SOLICITATION AMENDMENT

Title - Sujet Muncho Lake Maint. Camp Remediation	
Solicitation No. - N° de l'invitation EZ113-171168/A	Amendment No. - N° modif. 006
Client Reference No. - N° de référence du client	Date 2016-09-16
GETS Reference No. - N° de référence de SEAG PW-\$PWY-034-7860	
File No. - N° de dossier PWY-6-39125 (034)	CCC No./N° CCC - FMS No./N° VME
Solicitation Closes - L'invitation prend fin at - à 02:00 PM on - le 2016-09-28	Time Zone Fuseau horaire Pacific Daylight Saving Time PDT
F.O.B. - F.A.B. Plant-Usine: <input type="checkbox"/> Destination: <input checked="" type="checkbox"/> Other-Autre: <input type="checkbox"/>	
Address Enquiries to: - Adresser toutes questions à: Huchzermeyer, Chris(PWY)	Buyer Id - Id de l'acheteur pwy034
Telephone No. - N° de téléphone (604) 365-2956 ()	FAX No. - N° de FAX (604) 775-6633
Destination - of Goods, Services, and Construction: Destination - des biens, services et construction: PWGSC - Muncho Lake Maintenance Camp - Alaska Hwy, BC

This Amendment #006 is raised to:

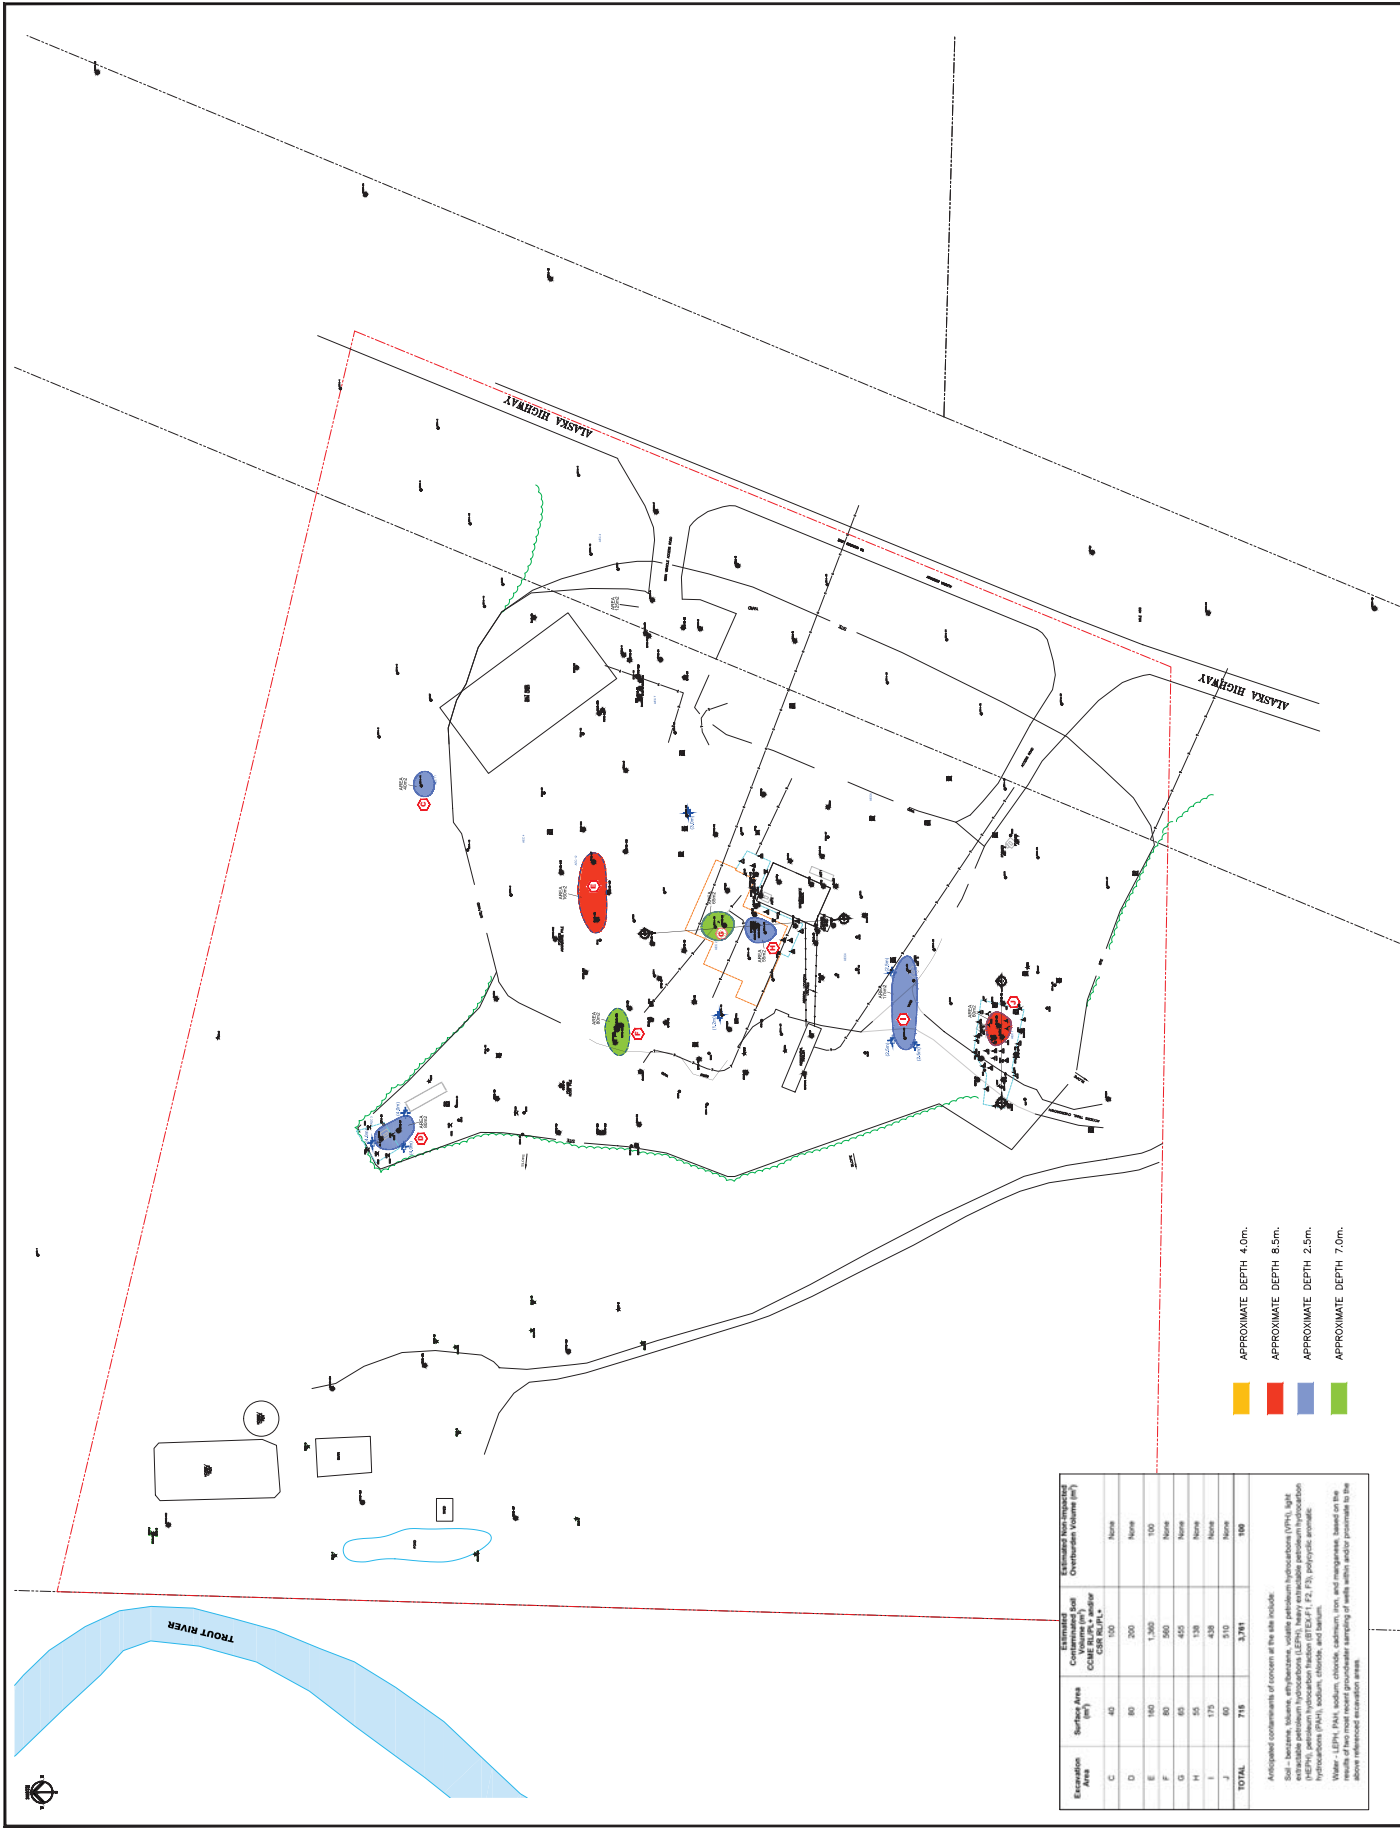
2. Drawing 635031-303 Contaminated Material Extents

Revision: Replace with attached Drawing 635031-303 Contaminated Materials Extents with excavation areas A and B removed
